**SITE PLAN**  
FOR  
**THE TAGG'S**  
BEING PART OF LOT NO. 21, TRACT NO. 1,  
IN THE TOWNSHIP OF PAINESVILLE, COUNTY  
OF LAKE, STATE OF OHIO

Grading Plan Approved  
as shown and/or noted  
**THOMAS P. GILLES, P.E.**  
Lake County Engineer

| LAKE COUNTY GENERAL HEALTH DISTRICT                |

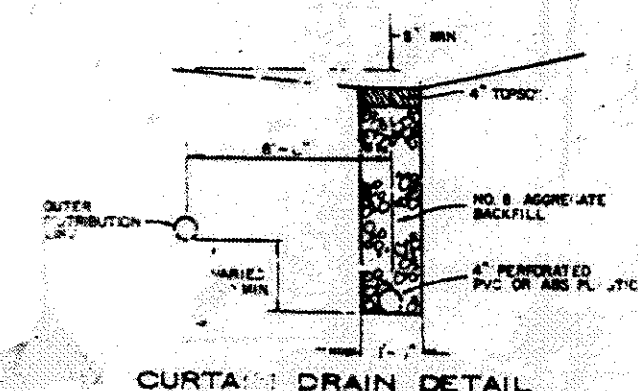
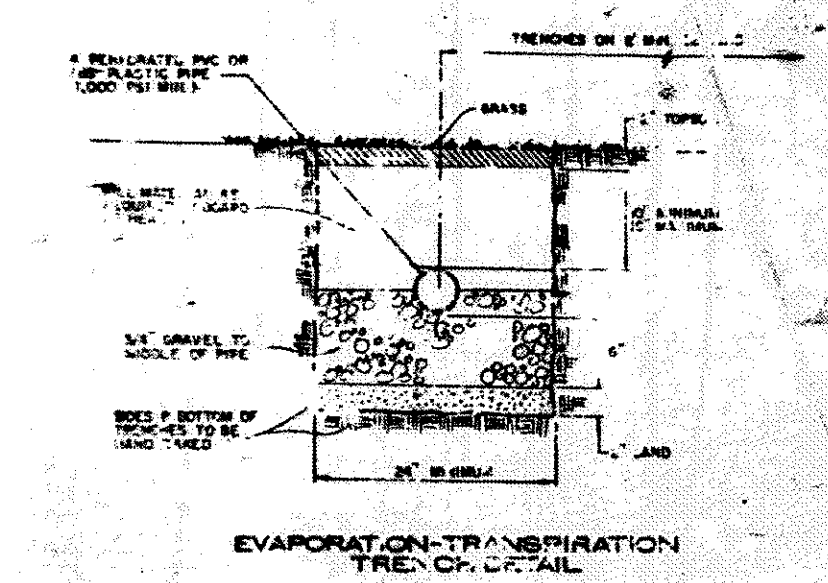
| <u>Avoid footer drain</u>                          |

FF-114.25  
GRINDER PUMP  
REQD IF PUMPING  
IN BASEMENT  
BSMT-104.92
